## MEETING NOTICE – SITE REVIEW COMMITTEE

**Date/Time: Wednesday May 26<sup>th</sup> 2021 (5:30 P.M.)**

#### **5. DISCUSSION AND ACTION – Request for a new 1,024 square foot detached accessory building (1200 Centennial Centre Blvd., HB-2490) (Page 7)**

#### **8. DISCUSSION AND ACTION - Consider a 136 unit, 8 building leased residential development with associated site improvements (1260-1274 Lear Ln., HB-L159) (Page 32)**

**A1.0**

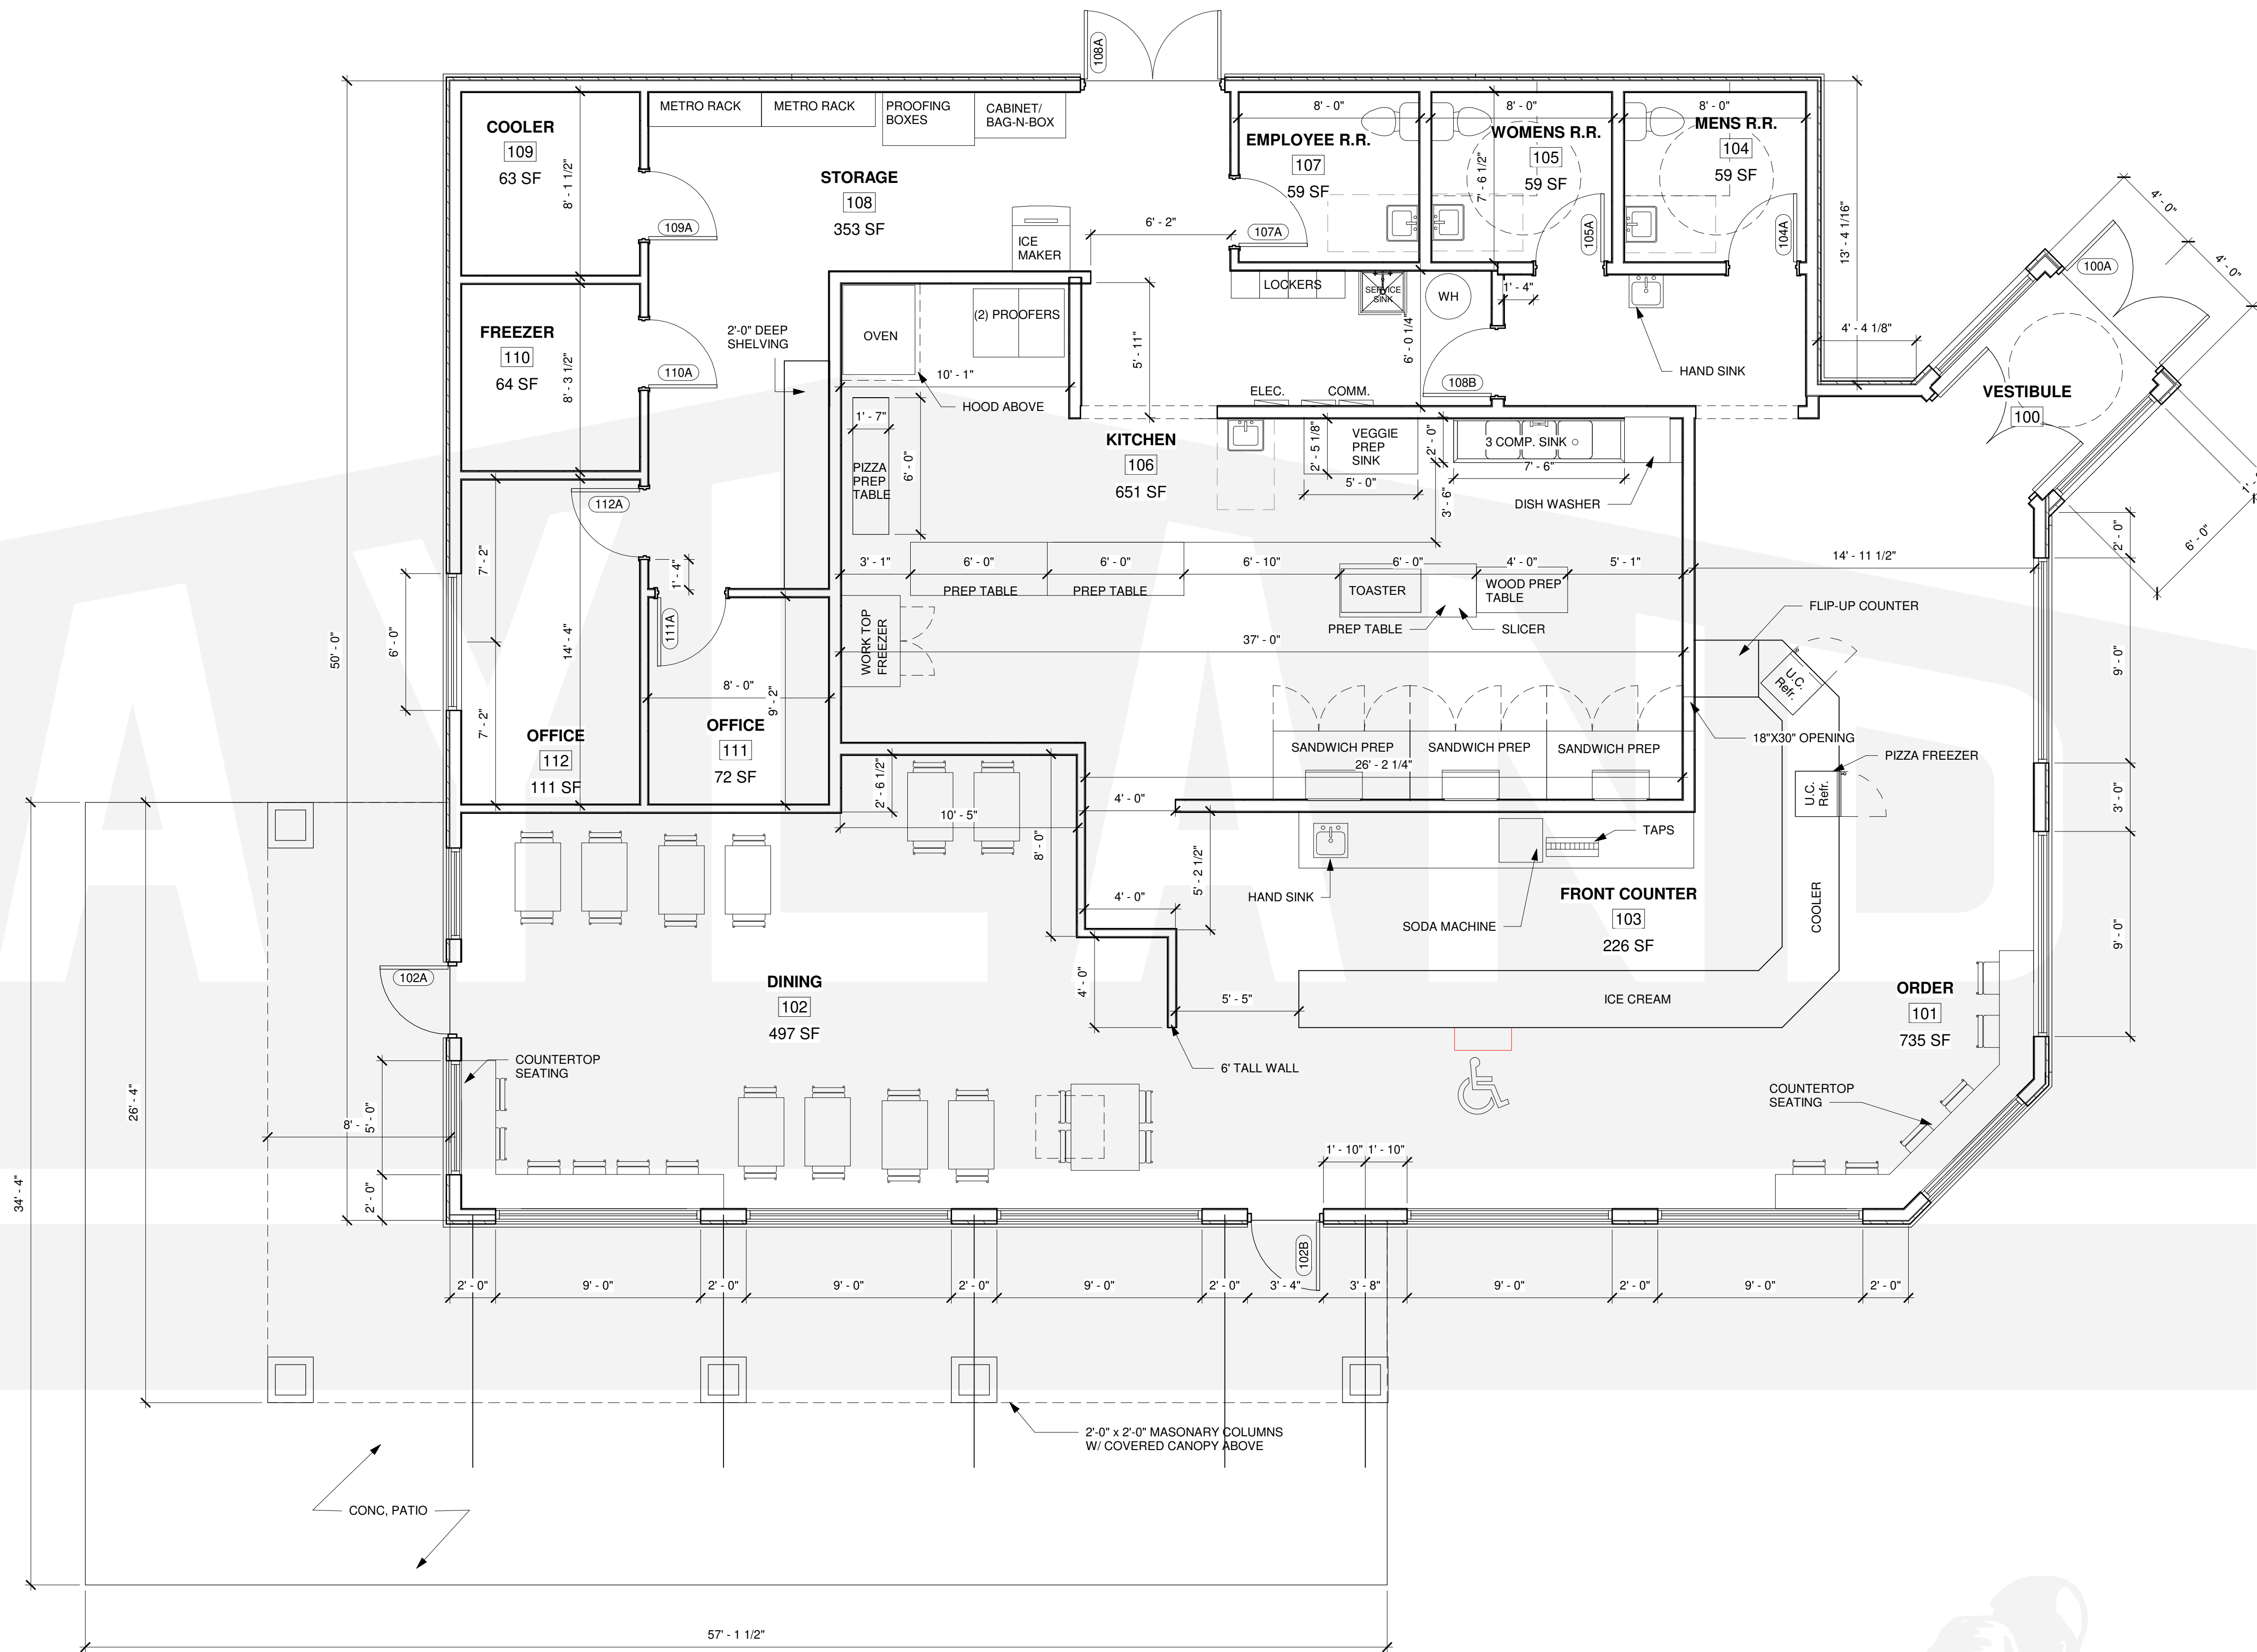
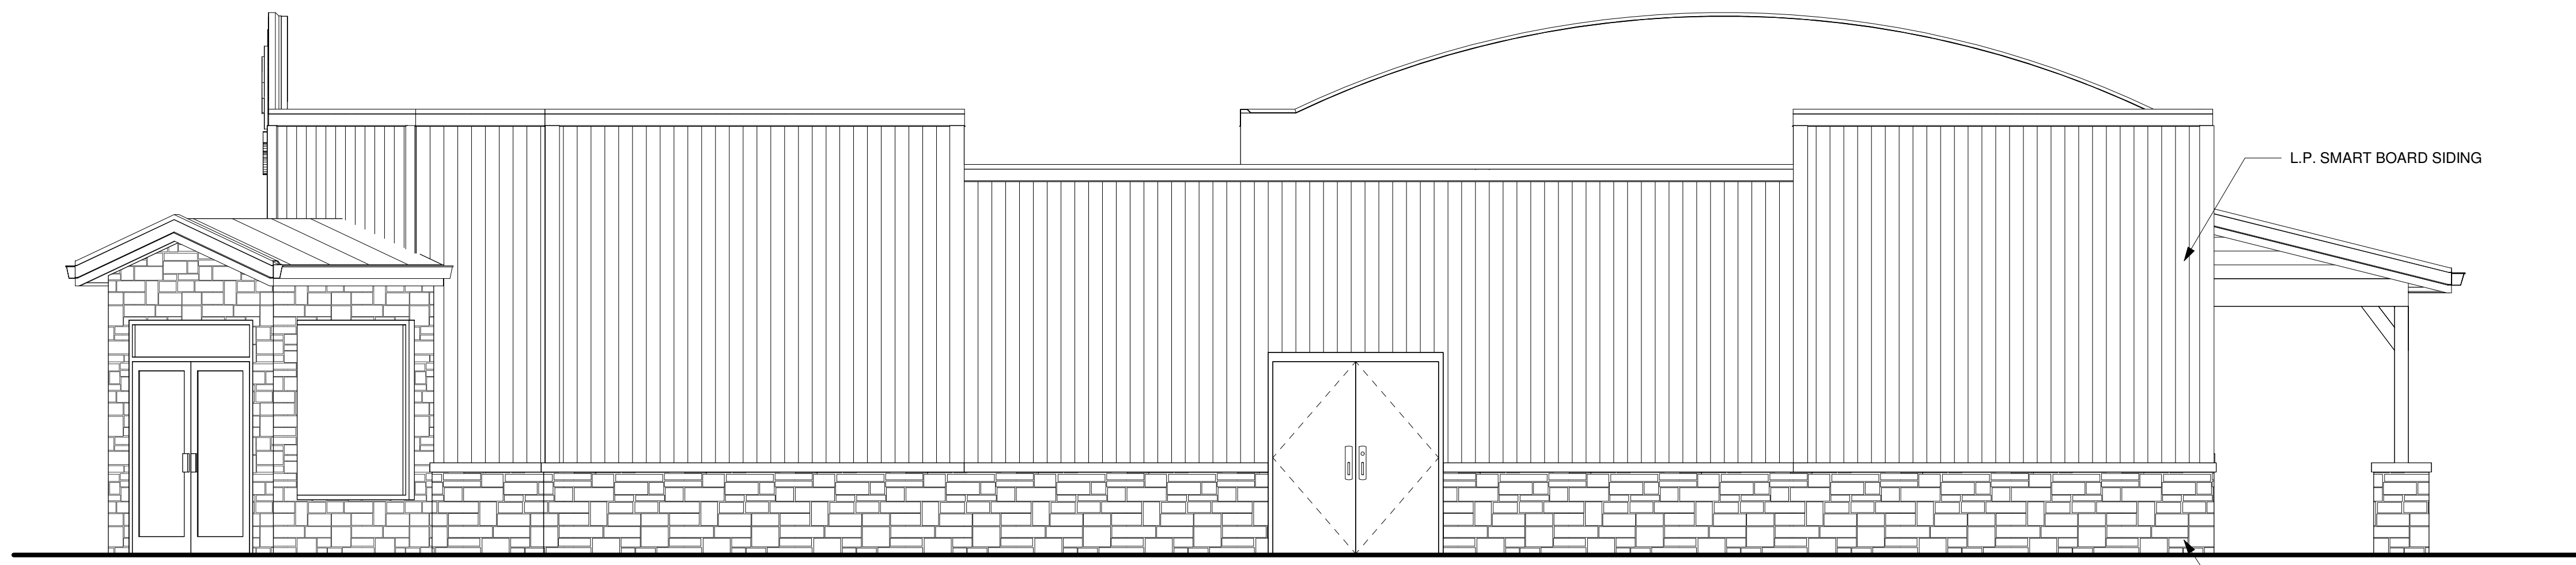
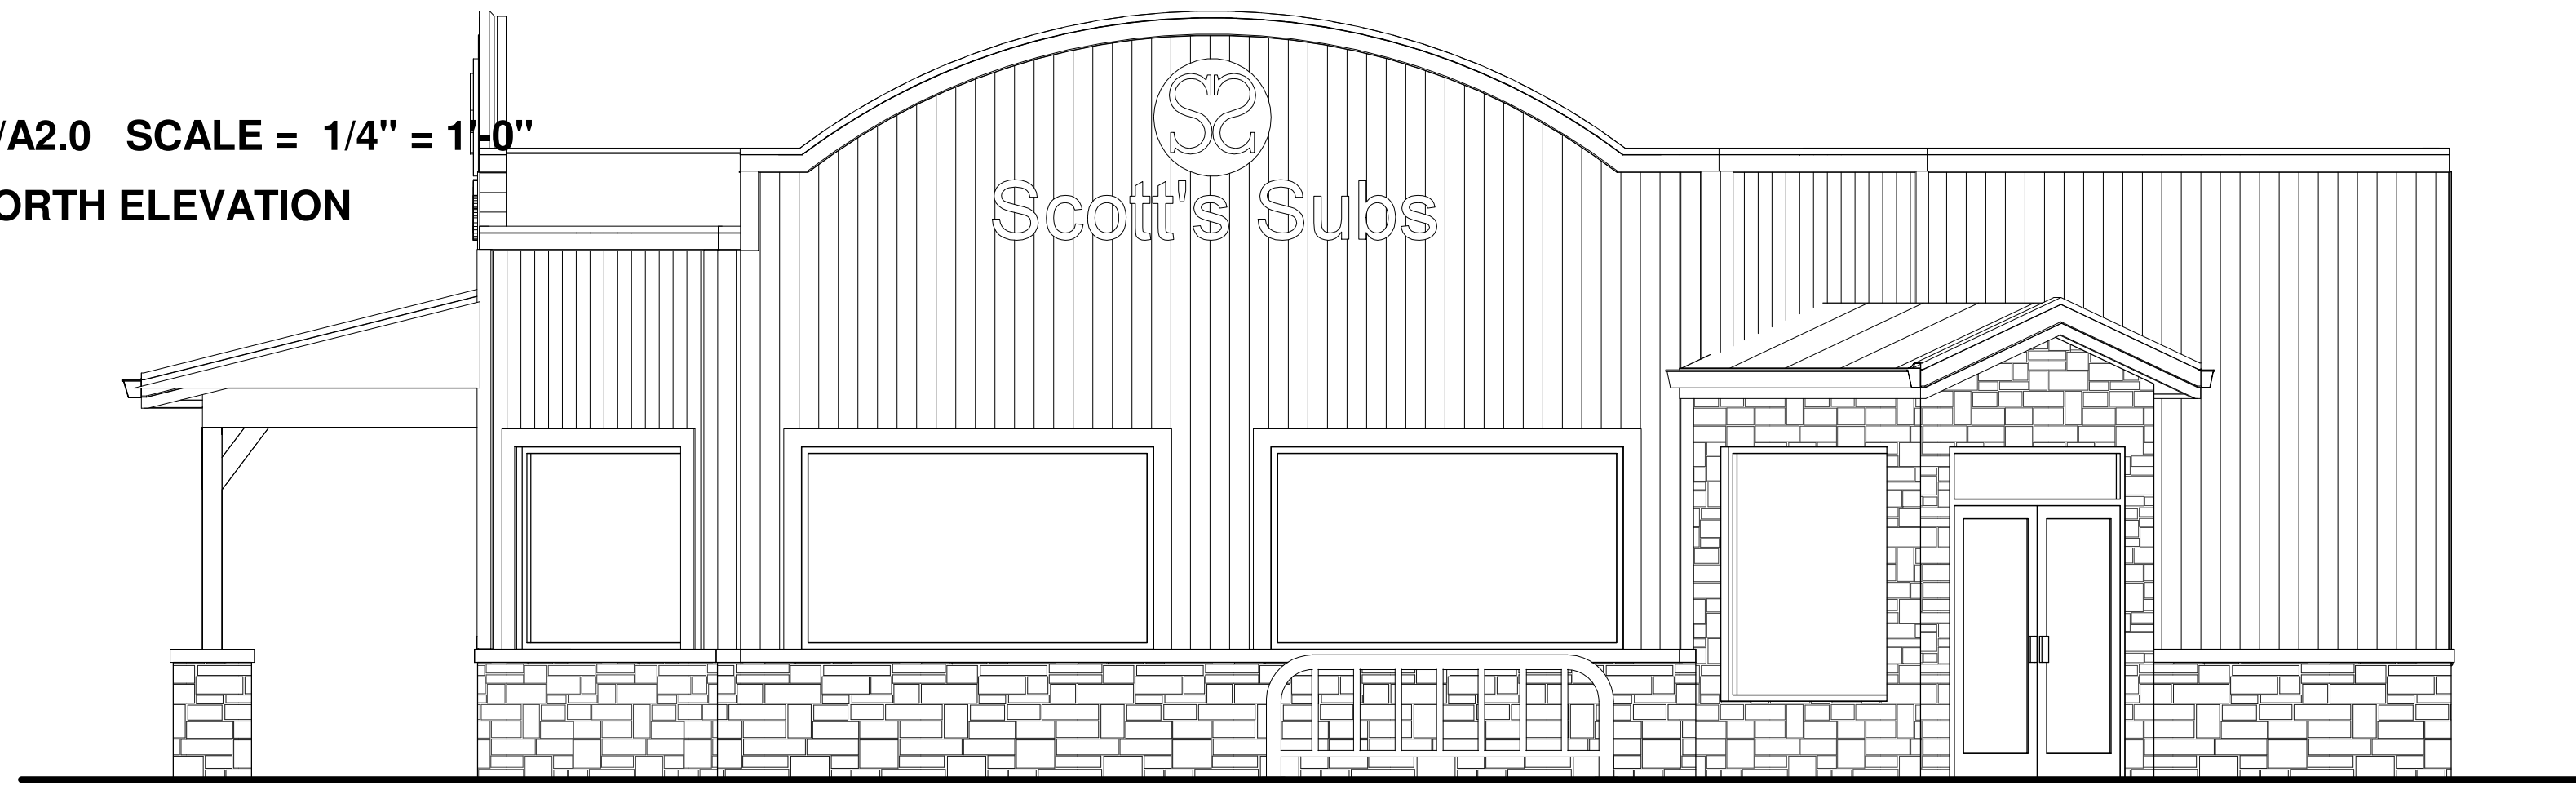
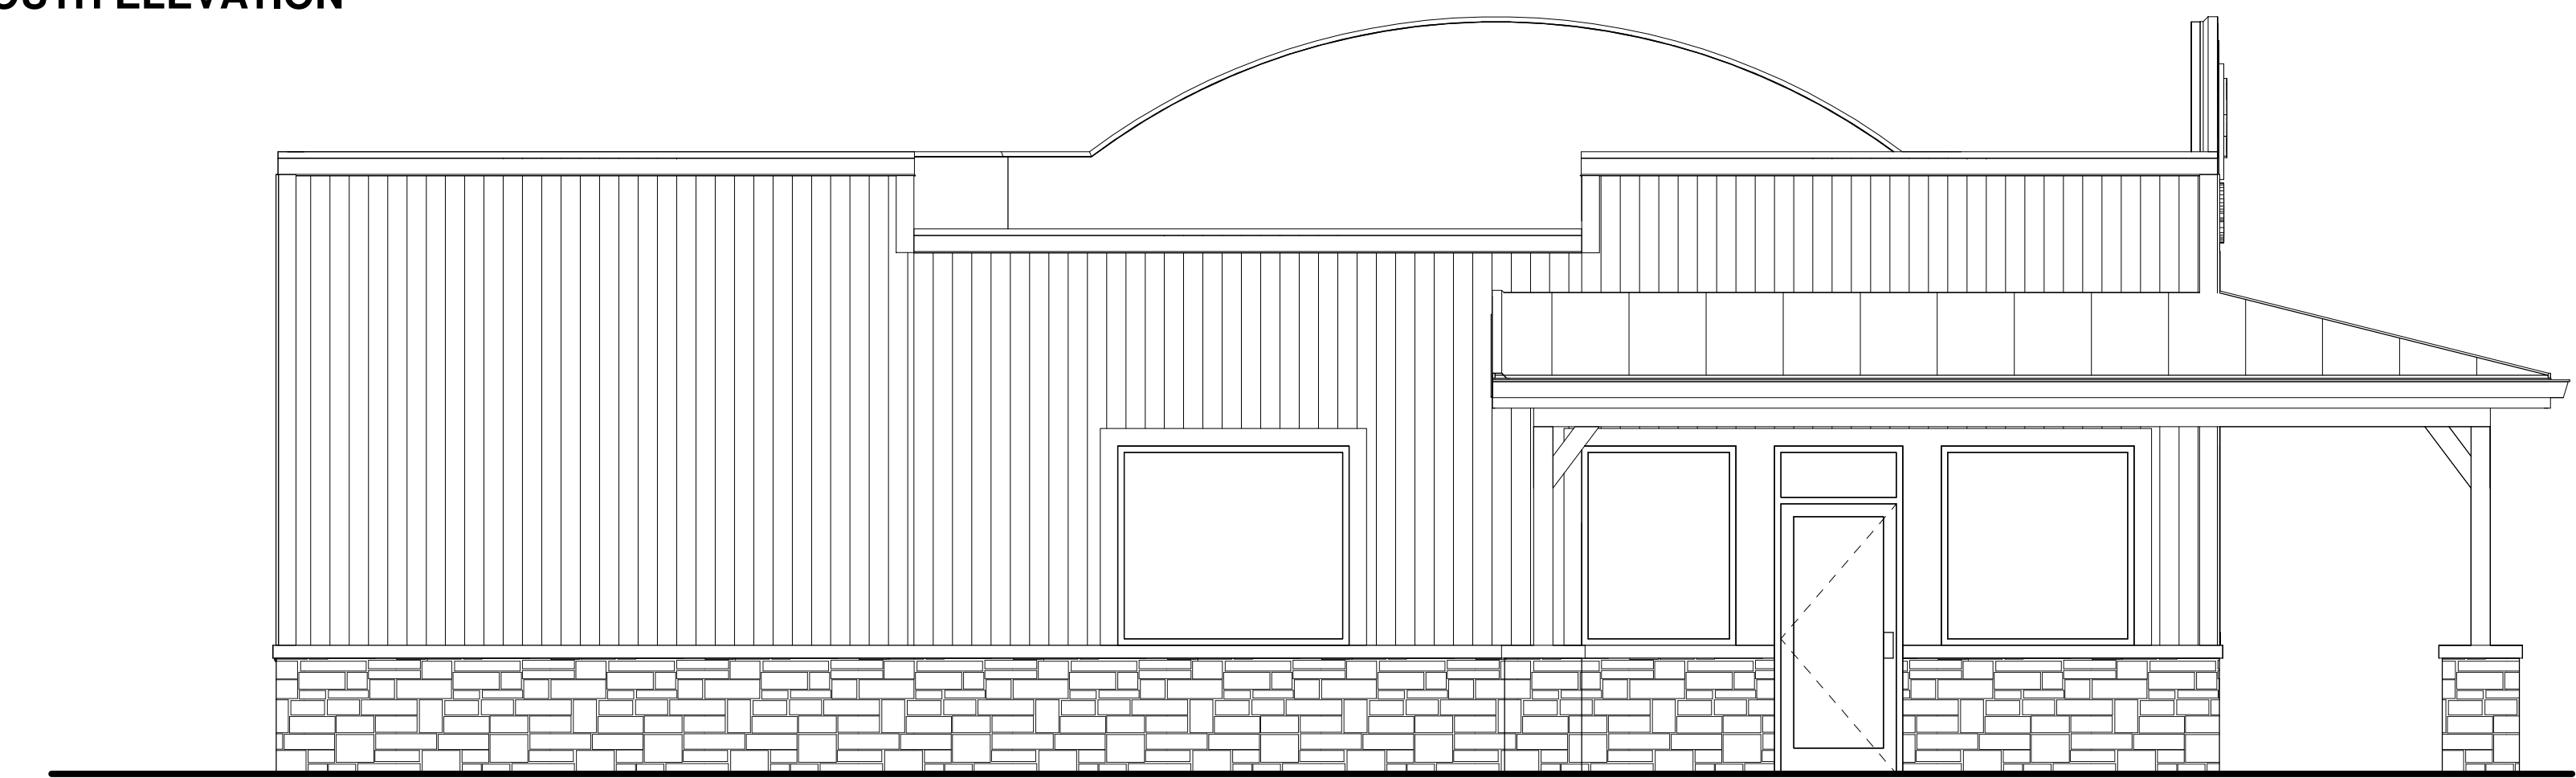
**G. Refuse Collection:** Proposed collection area is shown on this conceptual plan to be behind the proposed building. However, being that this site is near the round-a-bout, the enclosure will have high visibility from the roadway (Larsen Orchard Parkway) that runs alongside of this building, additional landscape screening should be planned along the west and north sides of the proposed enclosure.

1. Full submittal being reviewed and approved by the Site Review Committee at a later date;
2. Additional landscape screening should be planned along the west and north sides of the proposed refuse/recycling enclosure due to the high visibility from the roadway (Larsen Orchard Parkway) that runs alongside of this building
3. Any mechanical equipment if located on the roof or ground, shall be screen from view by materials compatible with the building or landscaping
